## Product Change Notification - SYST-21EDWO528

ERRATA - PIC32MX1XX/2XX/5XX 64/100-pin Family Silicon Errata and Data Sheet Clarification

## PIC32MX1XX/2XX/5XX 64/100-pin Family Silicon Errata and Data Sheet Clarification

## 17. Module: I/O Port - Initial Pin State

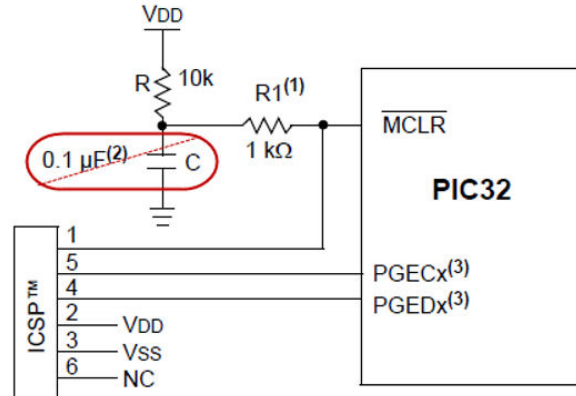
On power-up depending on the VDD ramp rate, the I/O pins can be in an active random output driving state if  $\overline{\text{MCLR}}$  is active until a BOR event.

If, not using an external reset supervisor IC or equivalent, remove the  $\overline{\text{MCLR}}$  capacitor as shown below, and retain the  $\overline{\text{MCLR}}$  Pull-up resistor.

If using an external reset supervisor IC or equivalent, increase the value of the VCAP capacitor to  $\geq 47 \mu\text{F}$  ceramic or solid tantalum capacitor with an  $\text{ESR} \leq 1 \text{ ohm}$ .
